CNL-15-132

Subject: **Tennessee Valley Authority's Browns Ferry Nuclear Plant Second Six-Month Status Report in Response to the June 6, 2013 Commission Order Modifying Licenses with Regard to Reliable Hardened Containment Vents Capable of Operation Under Severe Accident Conditions (Order-Number EA-13-109)**

TENNESSEE VALLEY AUTHORITY BROWNS FERRY NUCLEAR PLANT'S SECOND SIX-MONTH STATUS REPORT FOR THE IMPLEMENTATION OF ORDER EA-13-109, "ISSUANCE OF ORDER MODIFYING LICENSES WITH REGARD TO RELIABLE HARDENED CONTAINMENT VENTS CAPABLE OF OPERATION UNDER SEVERE ACCIDENT CONDITIONS"

Revision 1 of “Tennessee Valley Authority’s Phase 1 Overall Integrated Plan in Response to June 6, 2013 Commission Order Modifying Licenses with Regard to Reliable Hardened Containment Vents Capable of Operation Under Severe Accident (Order Number EA-13-109)”

Figure 2 - Mechanical I&C Flow Diagram Control Air System

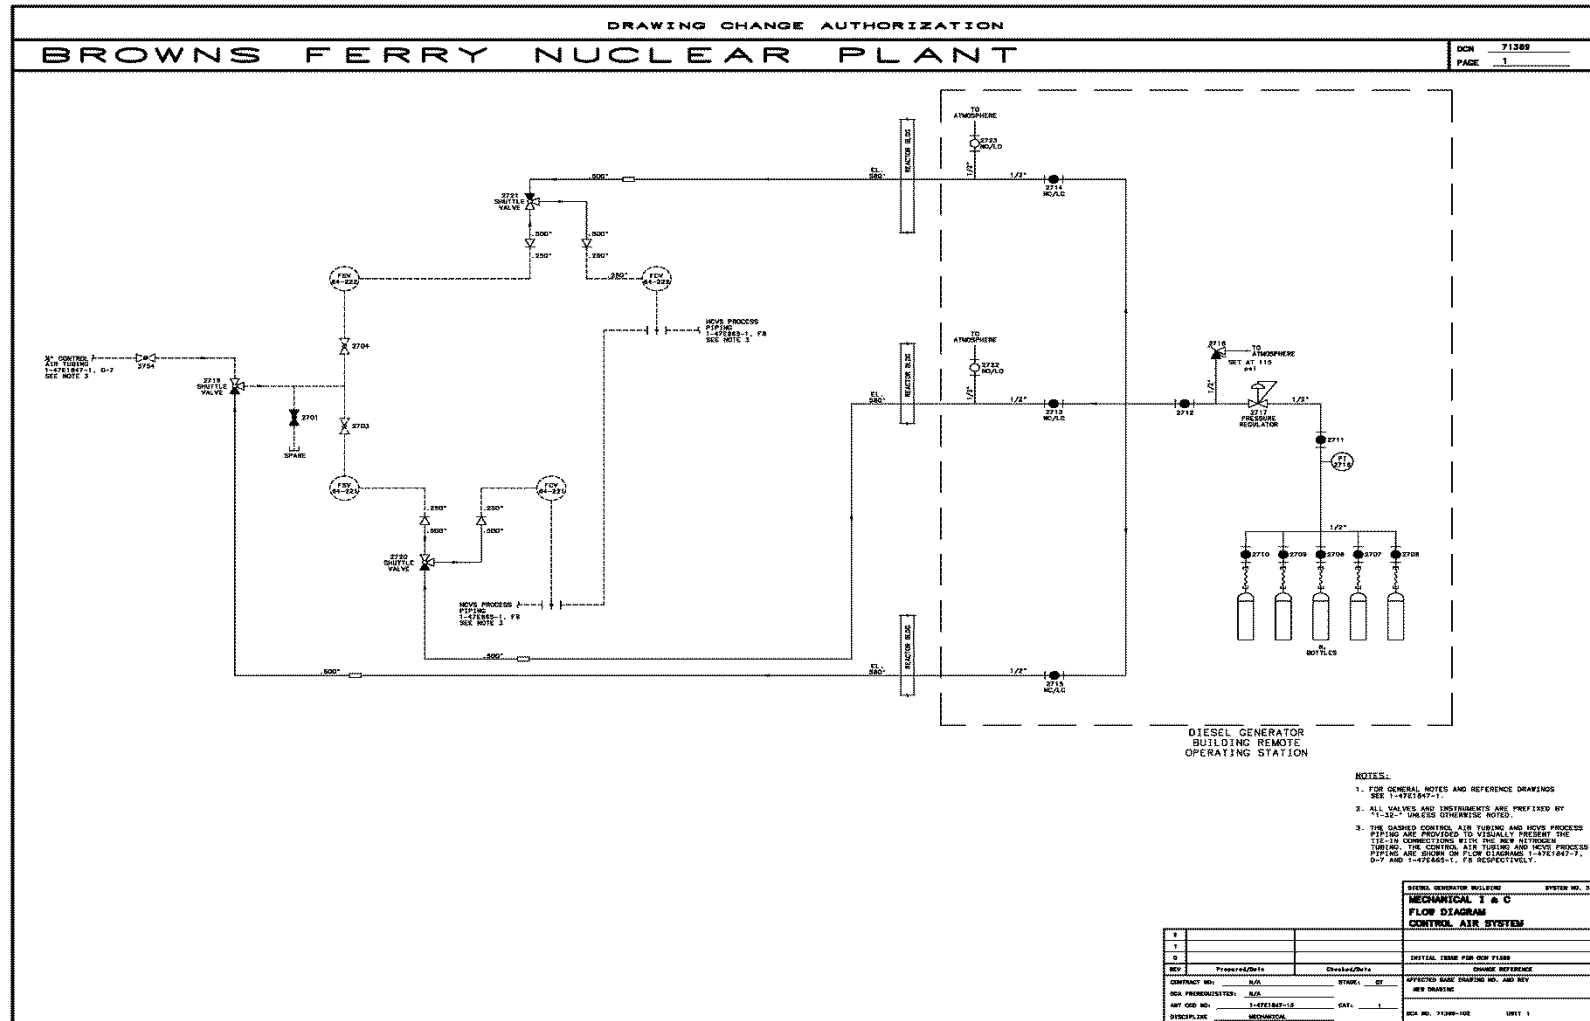
- Pages 38 and 39 of 59, Updated Table 4-1 “Testing and Inspection Requirements” to match Revision 1 of NEI 13-02.
- Pages 45 and 46 of 59, Updated Figures 2 and 3 to provide accurate description of the planned BFN design.
